## Determination 2009/56

### Determination regarding the refusal to amend a consent and issue a code compliance certificate for a 5-year-old block of 5 semi-detached townhouses at 131 to 139 Metcalfe Road, Waitakere City

3.1 The following site plan shows Block A:

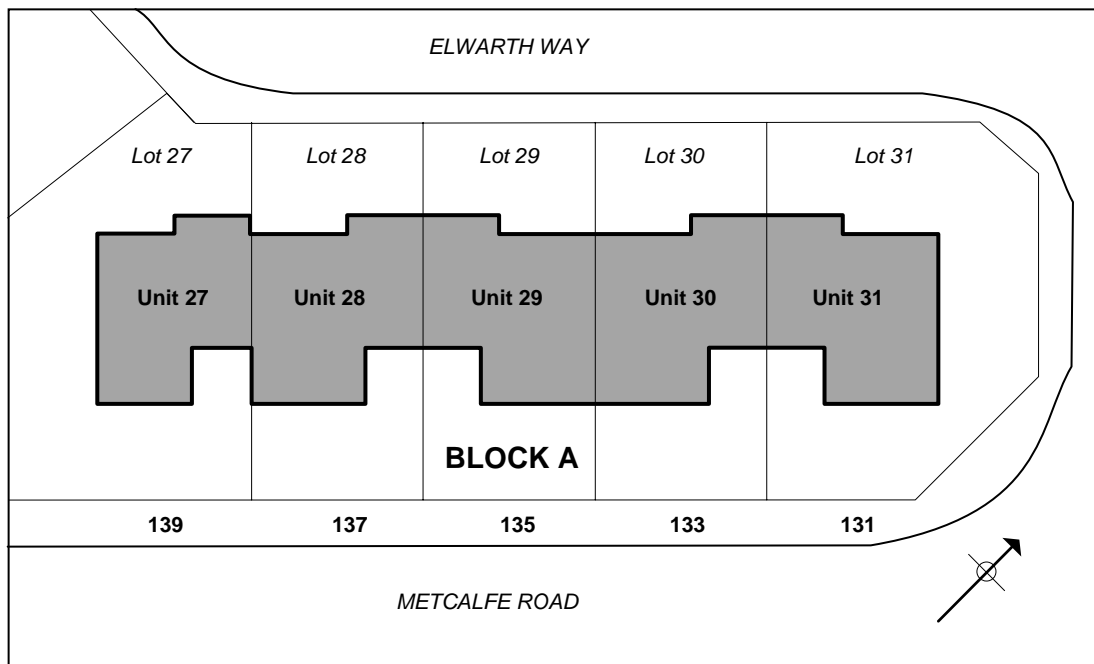
3.2 Block A is a two-storey building, which is situated on a flat site in a low wind zone in terms of NZS 3604<sup>3</sup>. The block sits parallel to Metcalfe Road, with the main

entries and garage doors facing the road. The building is fairly simple in plan and form, with garages set back from the front southeast wall. The ground floor of each unit accommodates living, dining and kitchen areas, with three bedrooms and a bathroom in the upper level.
